SUBJECT: MERCHANT'S TIRE AND AUTO CENTER
CASE NO. 84-152-XA
LANDSCAPE REQUIREMENTS

Case No. 84-152-XA

PETITION AND SITE PLAN

RE: Item No. 64 - Case No. 84-152-XA
Petitioner - Anthony F. DiPaula
Special Exception and Variance

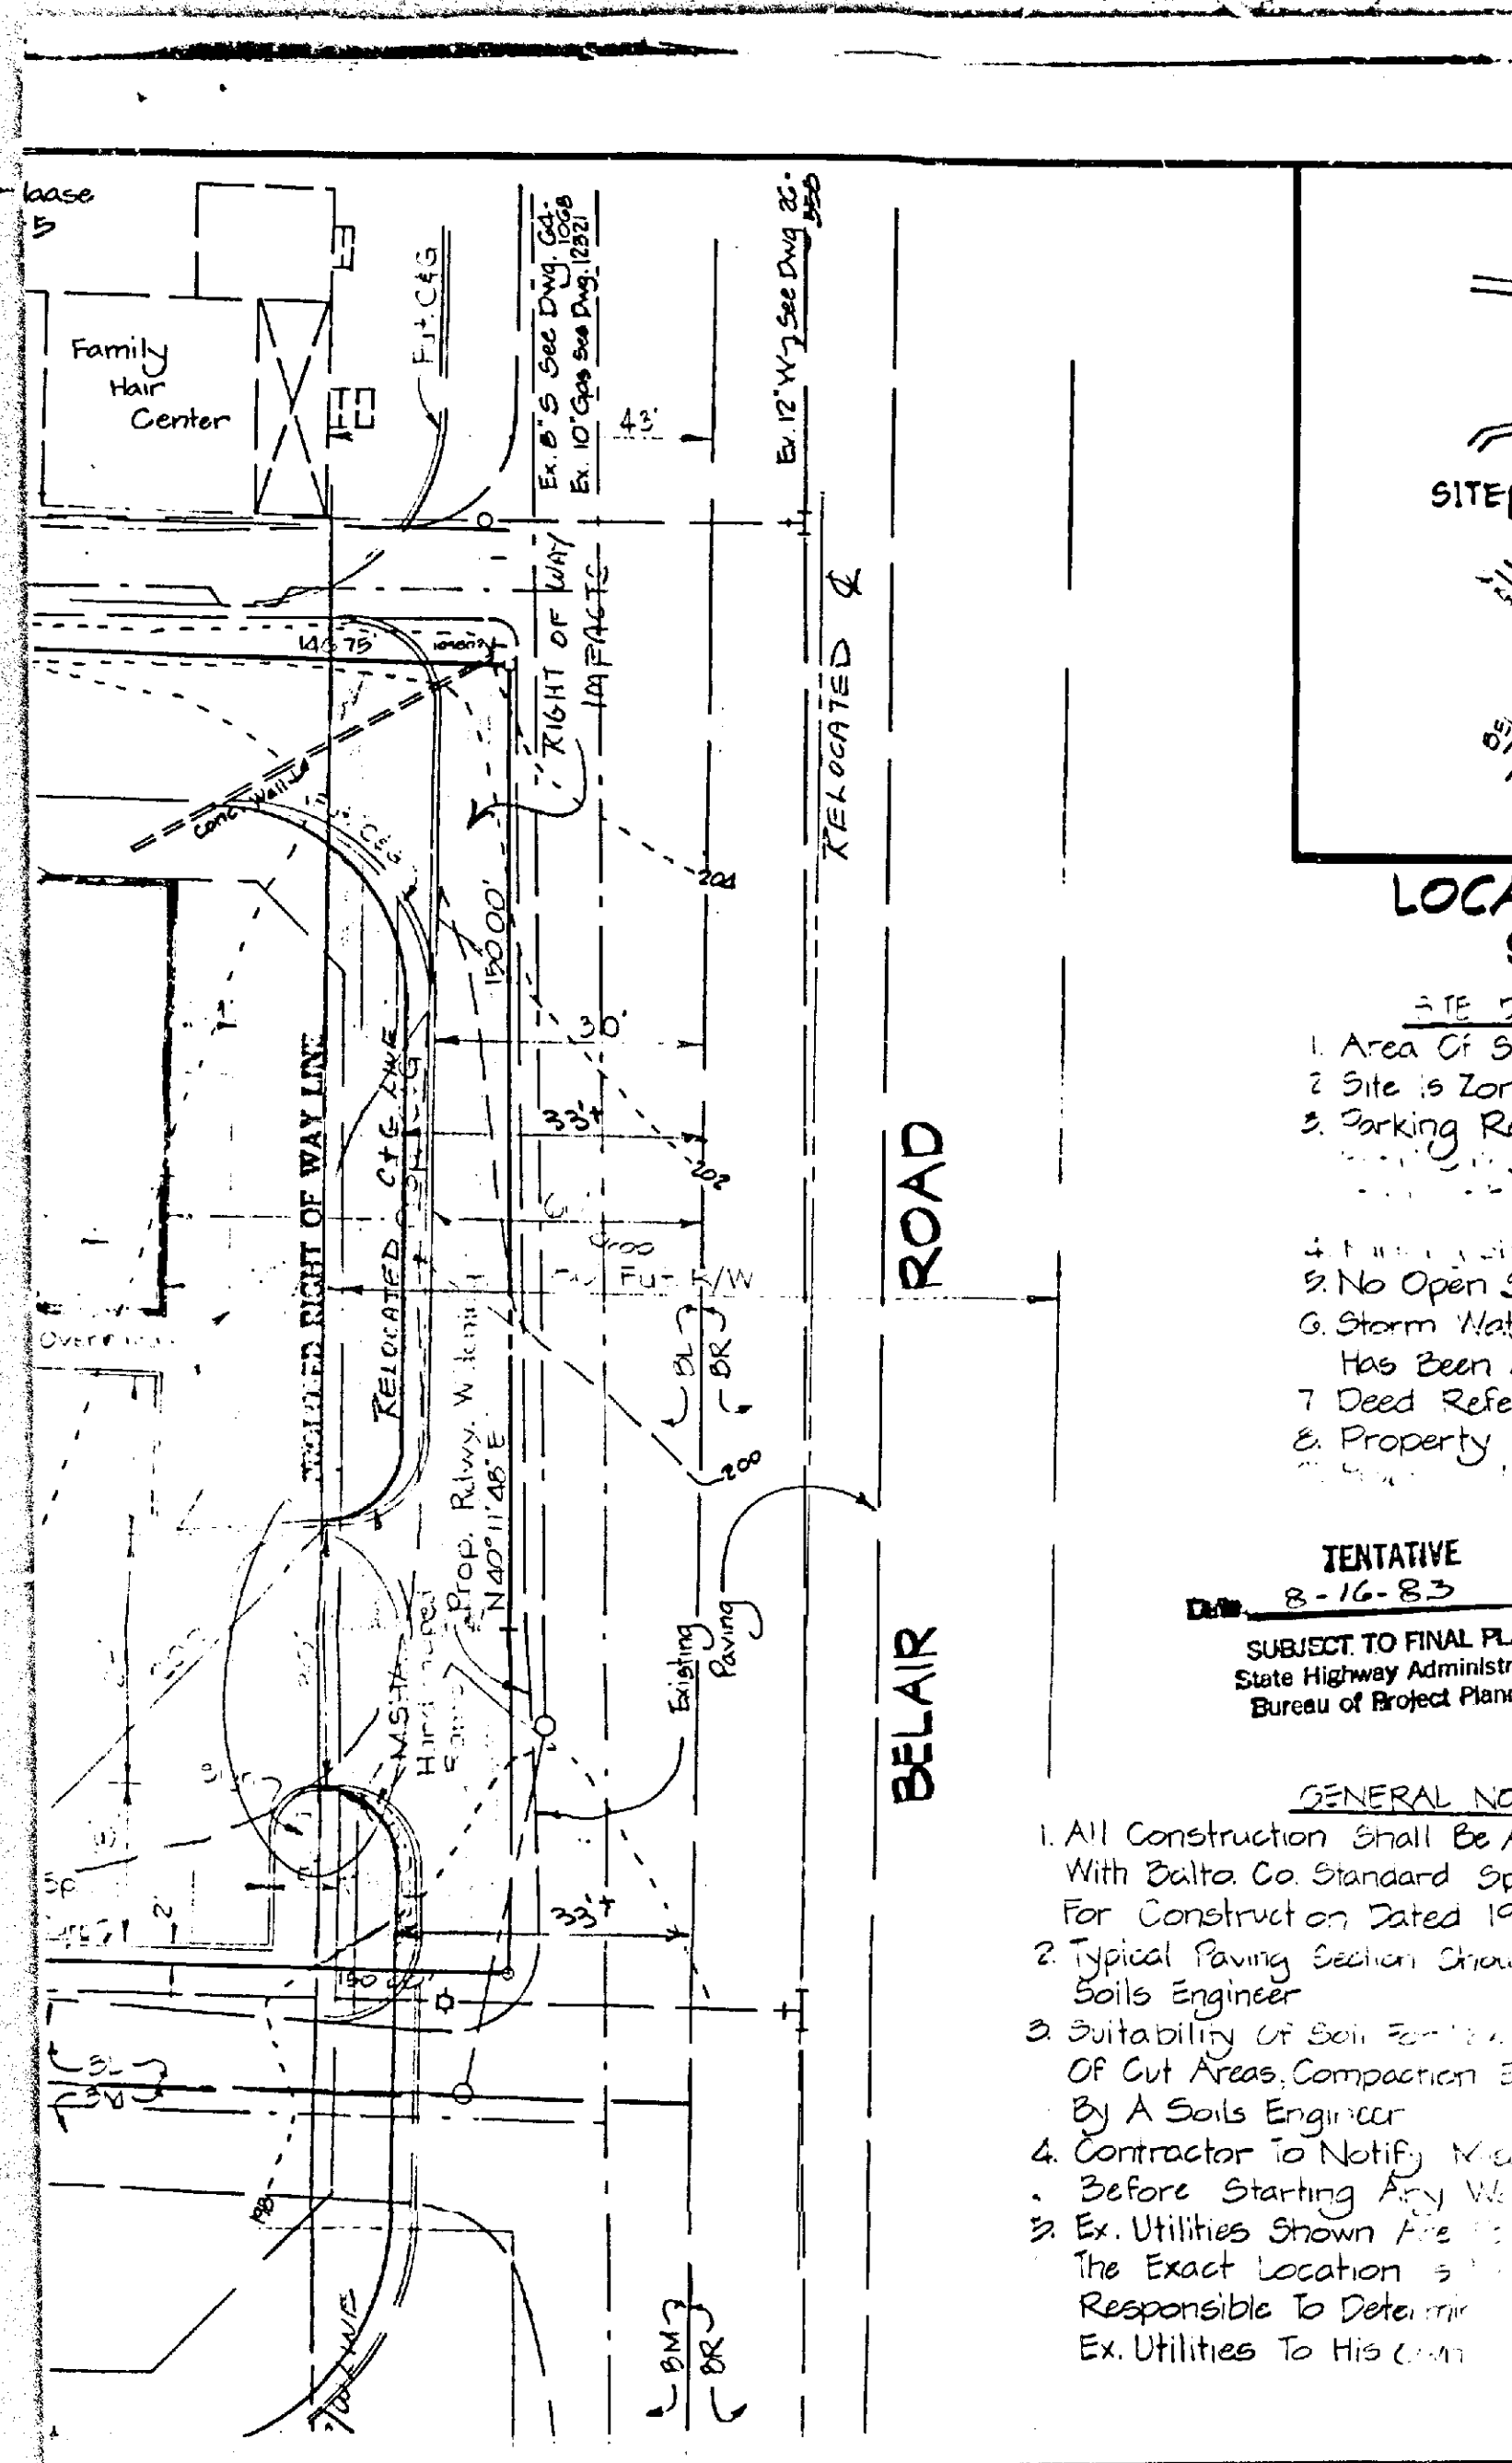
The State Highway Administration's Bureau of Project Planning has reviewed the site plan of 7-27-83 and offers the following comments:

The effects of the proposed improvements to U.S. Route 1 have been indicated on the attached plat for Merchants Tire Company, Inc., Belair Road & Graphill Road. The required right of way for the proposed improvements has been shaded in red. Be advised that the U.S. 1 study is in a preliminary stage and development, and that the alternatives and right of way requirements are tentative and subject to revisions.

PLAT TO ACCOMPANY PETITION FOR
SPECIAL EXCEPTION & BUILDING SETBACK VARIANCE *
MERCHANTS TIRE COMPANY INC.
BELAIR RD. & GRAPEHILL RD.
Baltimore Co., Md. Election District 14
Scale 1" = 20'
7/27/85
Rev. 10/31/85

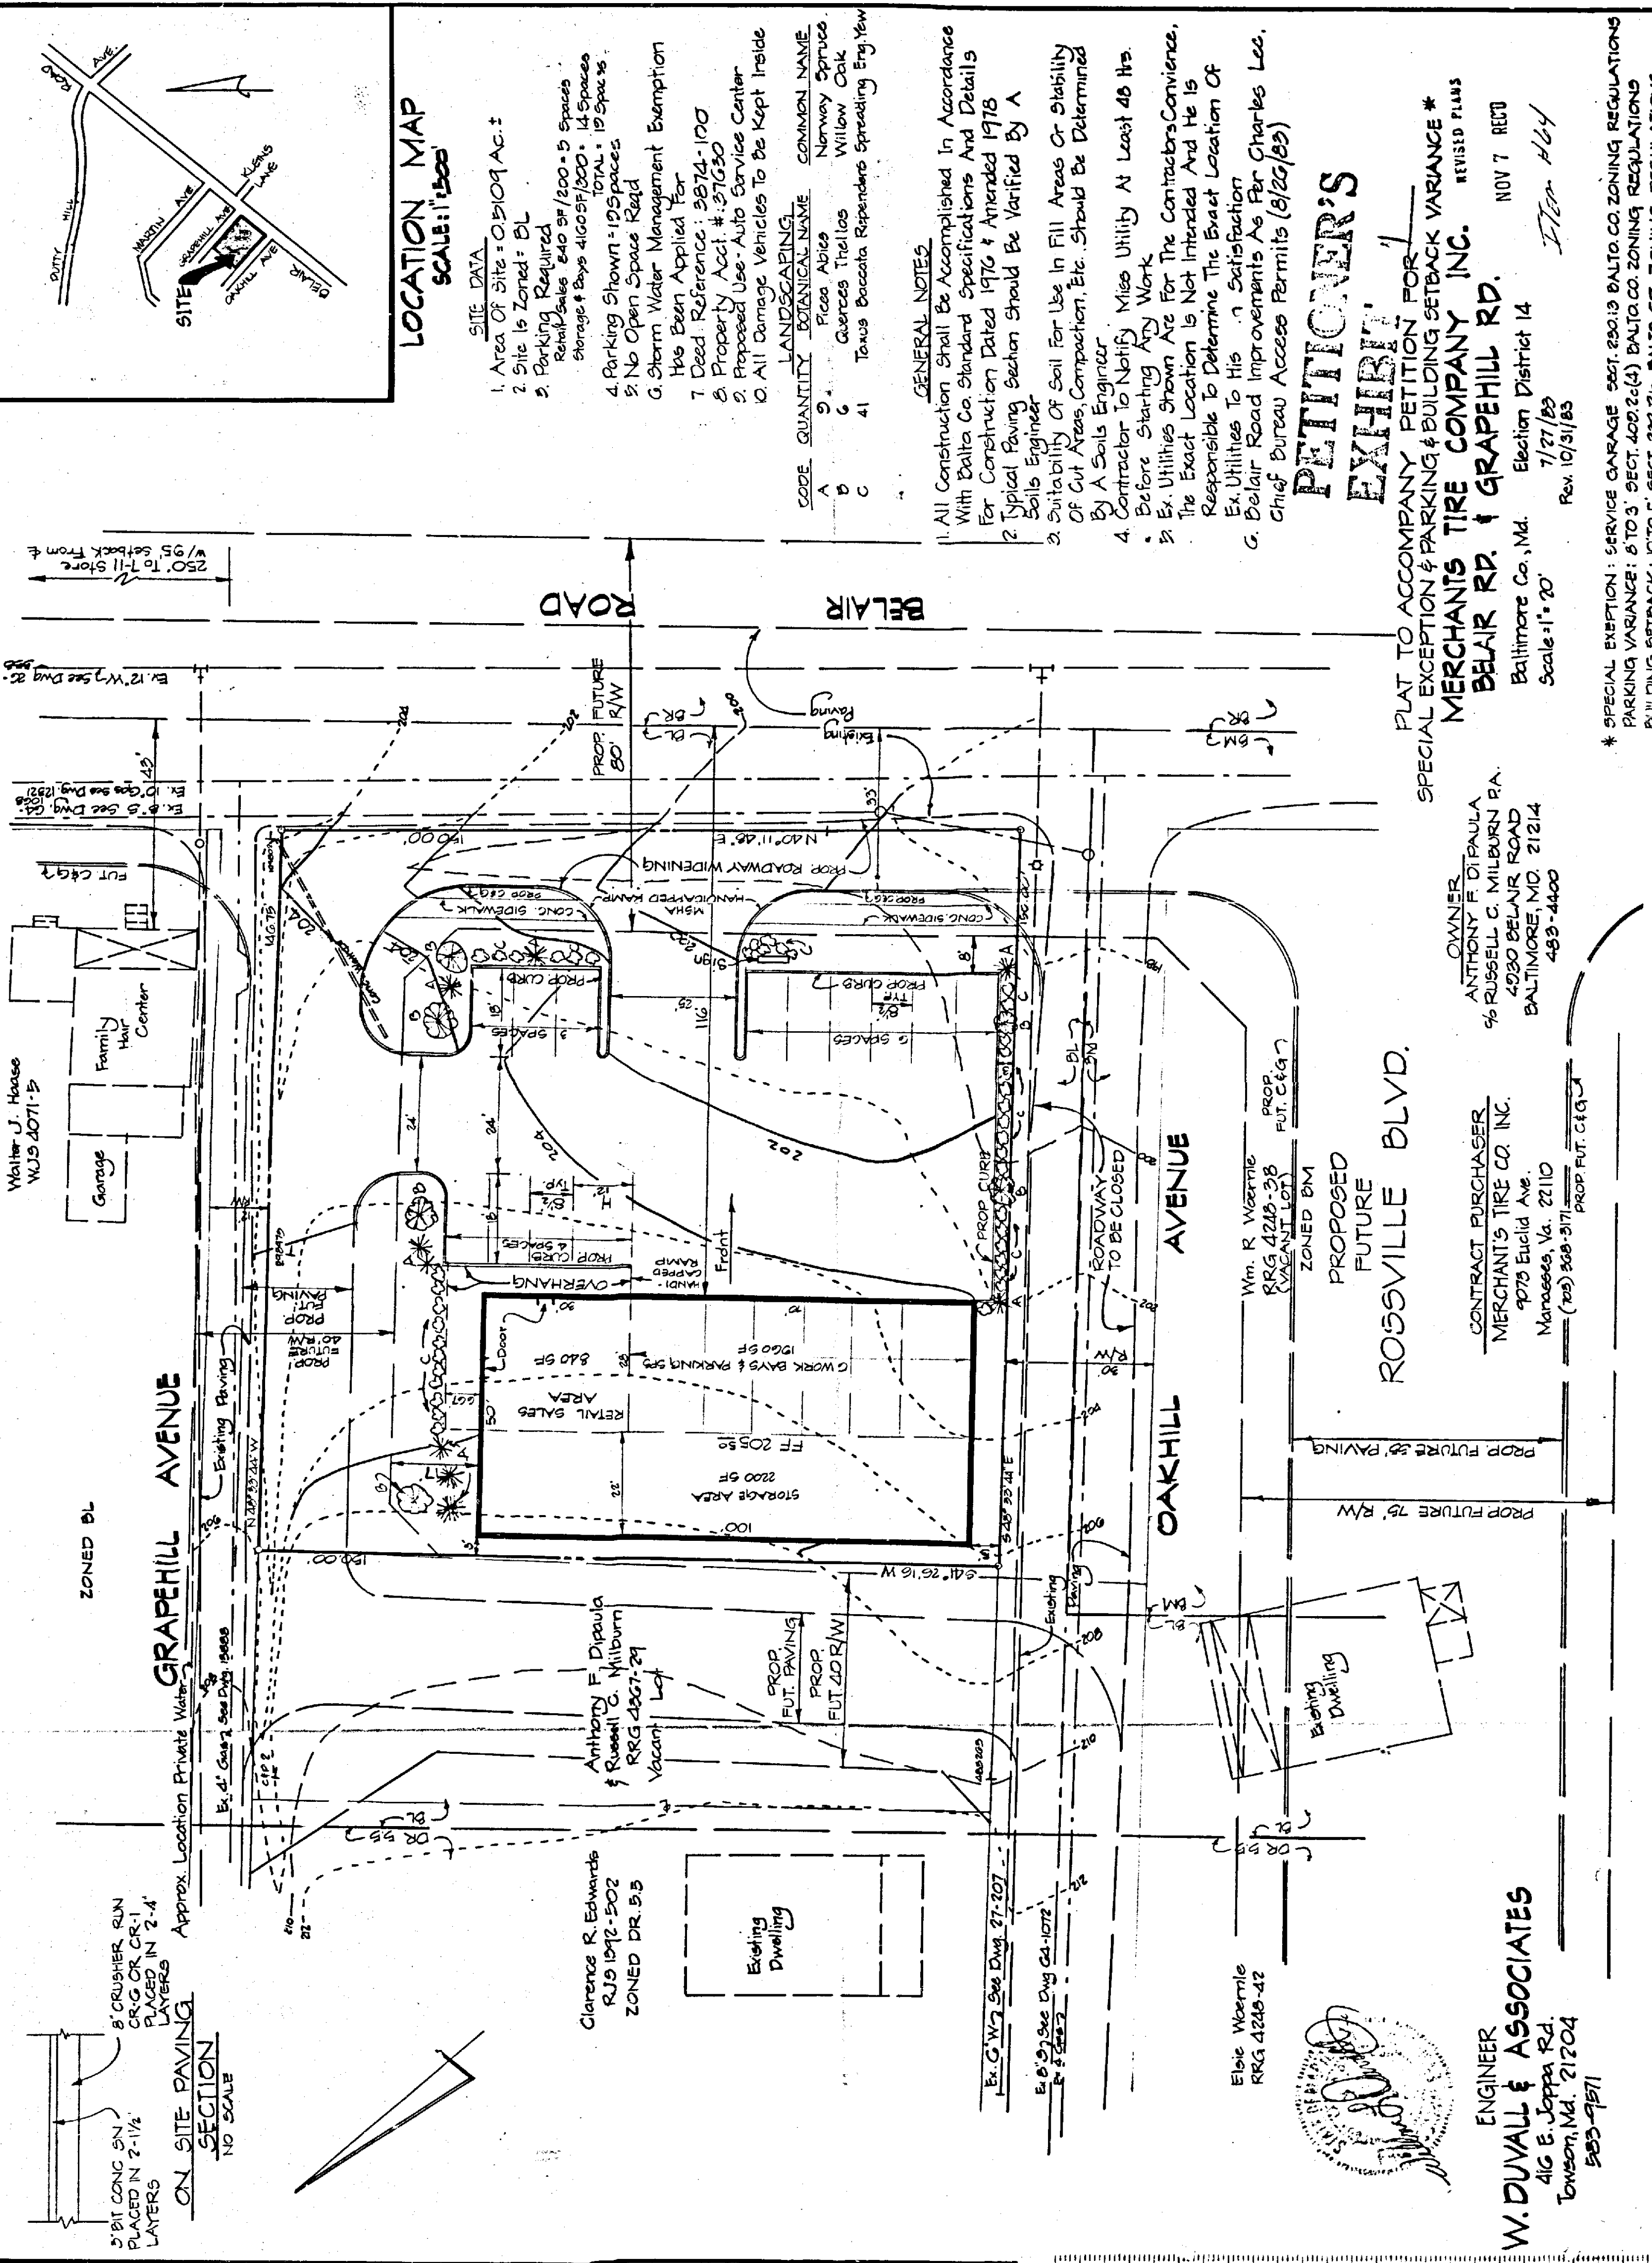
On review of the revised site plan of 10-31-83, the State Highway Administration finds the plan generally acceptable.
